SUB. AGITATOR SHAFT SLEEVE & ^
FOR DISC FILTER. (A, B & C)

DRG. NO. UC/M-781/A

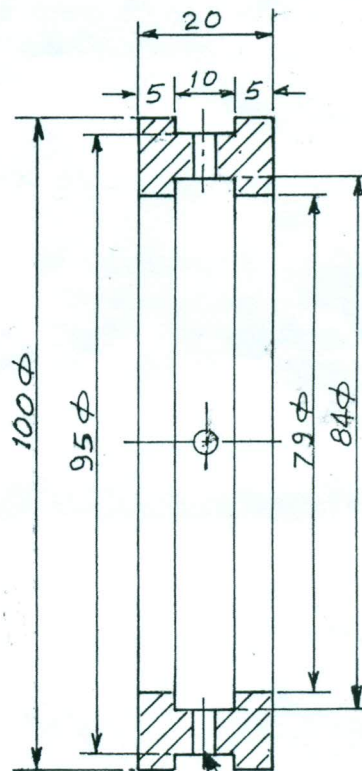
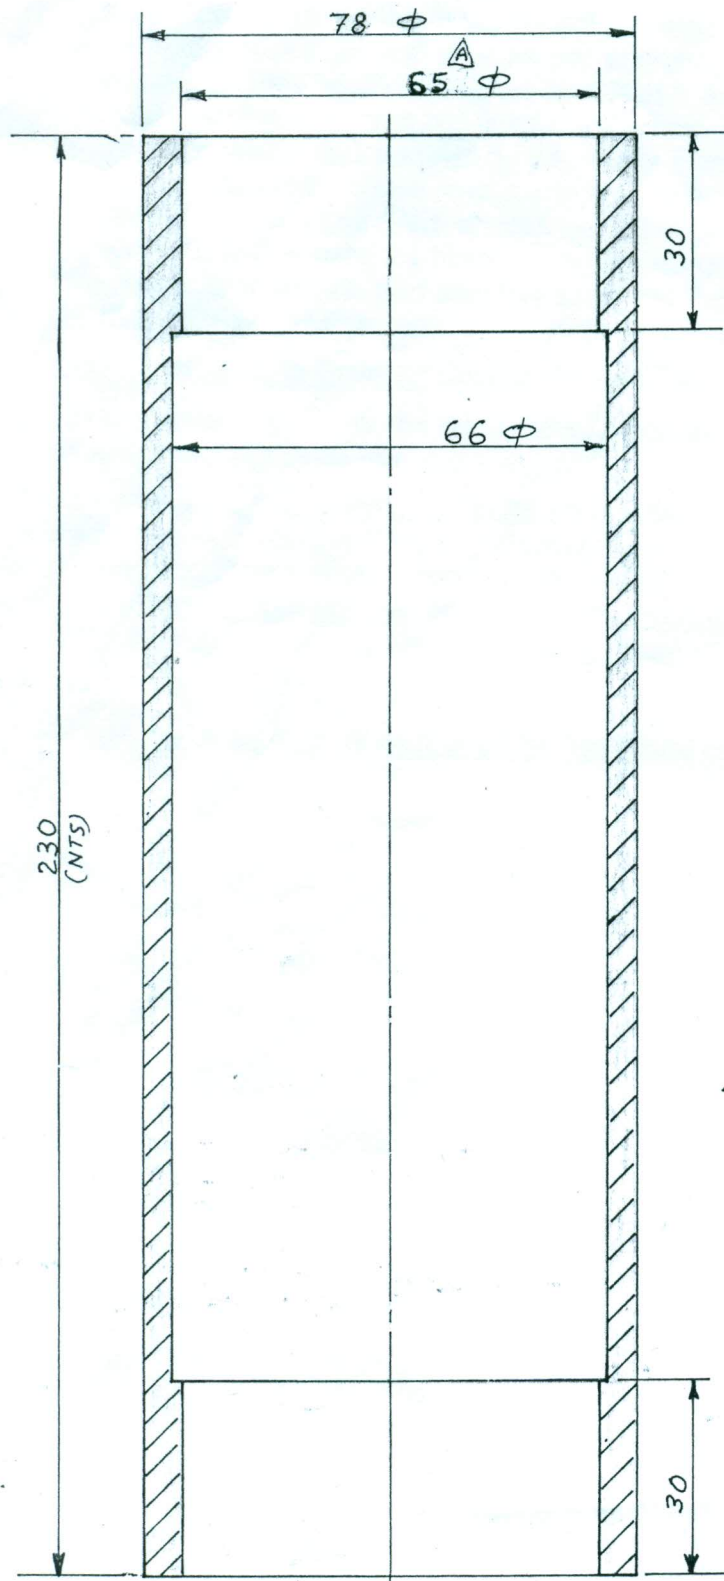
REV. 'A'

I.D. CHANGED FROM 63.8 mm
TO 65 mm BY S. SUR ON

9.3.2000.
